**From:** AWeinberg@nobleenergyinc.com  
**Sent:** Monday, October 14, 2013 10:26 AM  
**To:** arthur.koepsell@state.co.us  
**Subject:** Re: WELLS RANCH PC USX AA Sundry noitce (Doc # 400492161)  
**Attachments:** Access Postcard.pdf; ATT00079.txt

From: "Koepsell - DNR, Arthur" <[arthur.koepsell@state.co.us](mailto:arthur.koepsell@state.co.us)>  
To: [aweinberg@nobleenergyinc.com](mailto:aweinberg@nobleenergyinc.com)  
Date: 10/10/2013 02:07 PM  
Subject: EXTERNAL: WELLS RANCH PC USX AA Sundry noitce (Doc # 400492161)

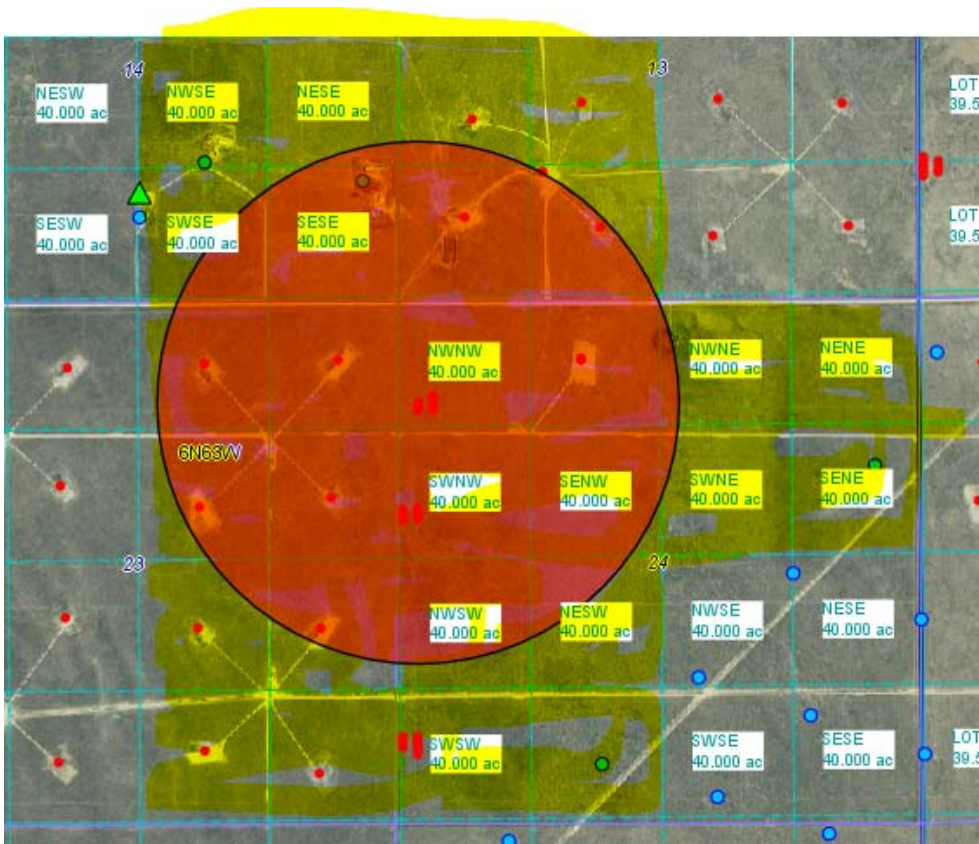
There are two wells water that may be used as water sources under rule 318ae4. One is in the NE quarter of section 24 (permit # 77005-F) and the other is in the SW quarter of section 24 (permit #77137-F). Both of the wells appear to be owned by Wells Ranch. In order to process the sundry we will need proof of your good faith efforts to collect samples from the wells.

Something to keep in mind when looking for wells under 318Ae4 is that the 1/2 mile radius is trying to find 1/4 sections that contain water wells not necessarily the water wells themselves.

In the figure below I tried to highlight how the COGCC interprets rule 318 Ae4. There is the 1/2 mile radius around the well with the 1/4 sections that it comes into contact with highlighted. Any water well in the

highlighted 1/4 sections could be sampled to meet 318ae4. The exception to this is the SE 1/4 of section 14, because there is already an established sample location. Since there is a sample location established in that 1/4 section it is necessary to look for a different 1/4 section and well.
